# Product Notification

## PT-023360-RE

**Subject: Insulation Boot 11328 - Product Change Notification**

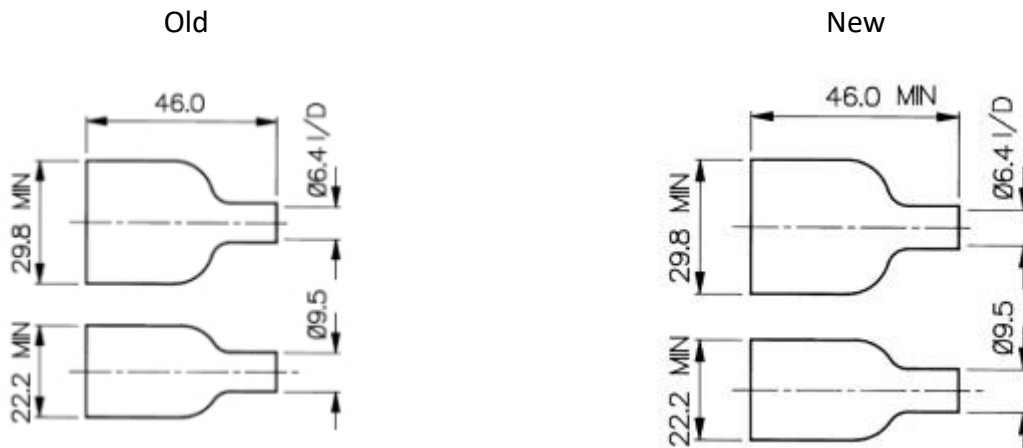
A revision has been made to the drawing reference for Insulation Boot 11328. The overall length of the insulation boot is now specified as a minimum of 46.0 mm, and this dimension has been included in the product datasheet.

This revision has been implemented to eliminate potential ambiguity in the previously published drawing and to enhance clarity regarding the dimensional specifications. Please note that this update does not constitute a change to the design, form, fit, or function of the product. All existing and currently supplied parts remain the same; the revision is solely intended to clarify the dimensions of the product as supplied.
